Re: Staff Approval of the Proposed Temporary Barricade System located along the Two Cambridge Center Public Pedestrian Easement

Re: Two Cambridge Center Public Pedestrian Easement

Attachment B: Proposed Temporary Barricade System

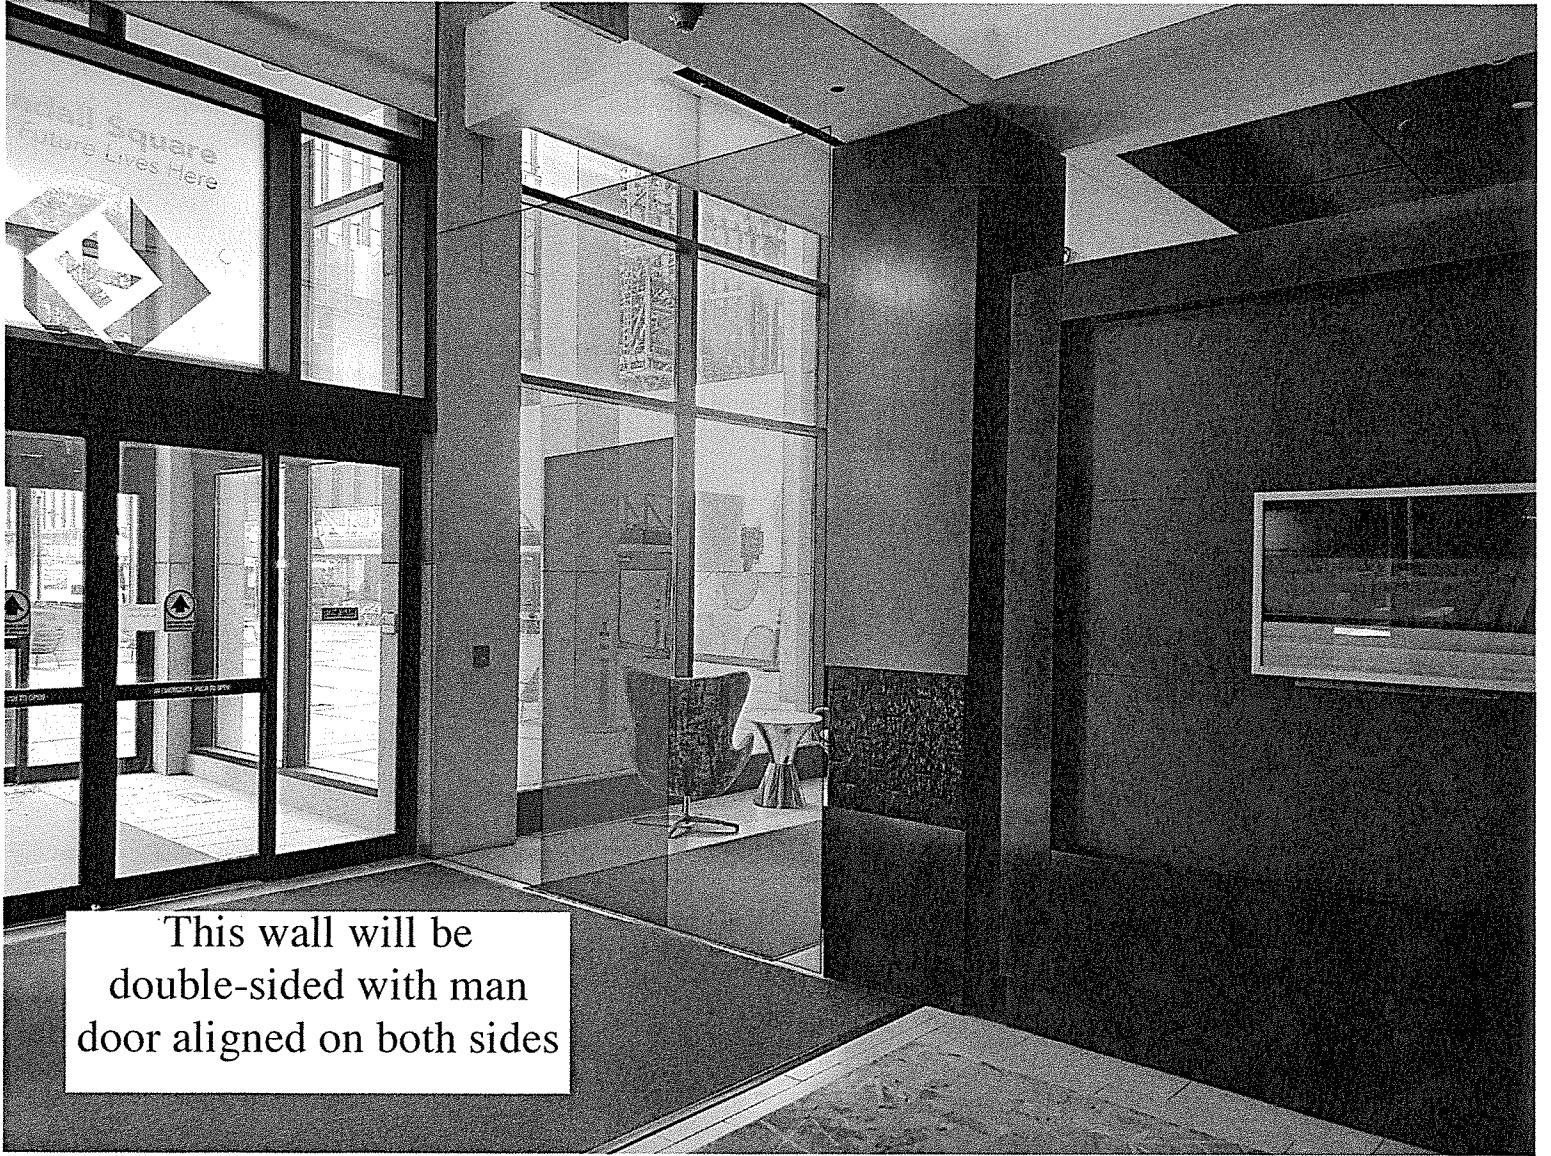
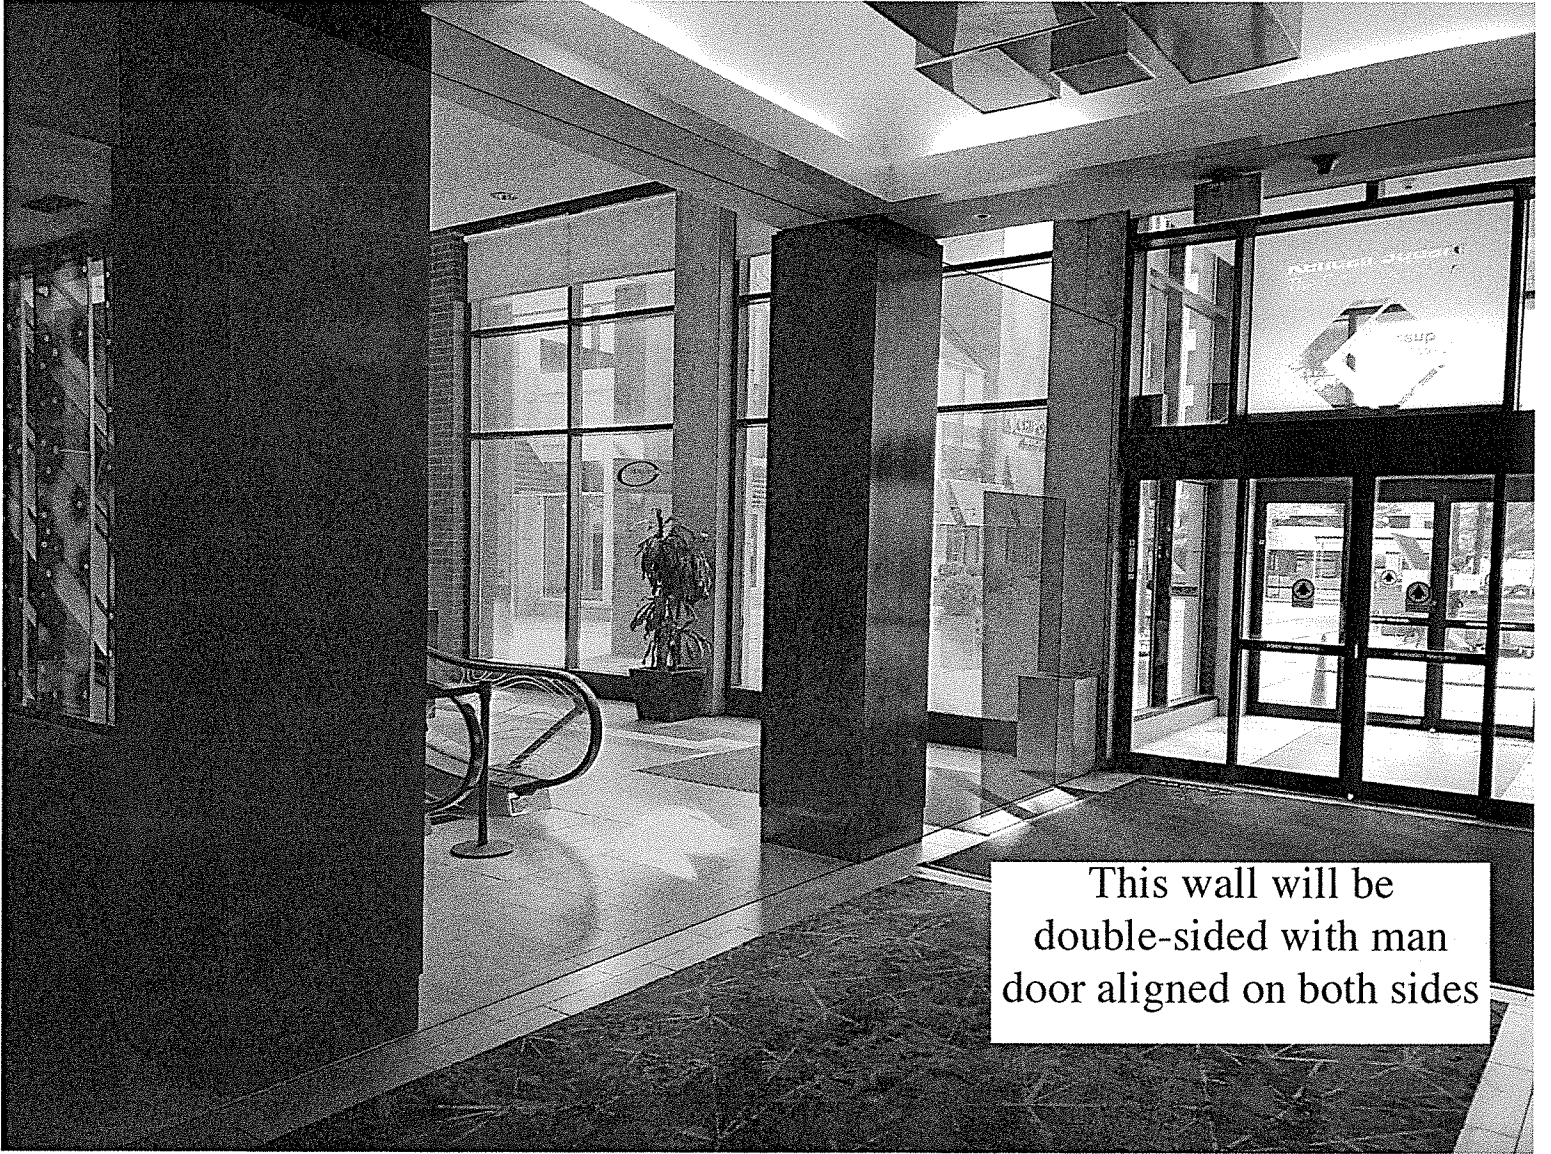
- The Temporary Barricade System shall be removed upon the earlier of the lifting of the Governor's COVID-19 state of emergency or the opening of the Marriott Hotel conference center.
- Graphics will be applied to the public facing surface of the walls and the shall include signage to provide COVID-19 social distancing information along with an explanation of the temporary status of the wall installation.
- The Temporary Barricade System should include art on a majority of the walls.
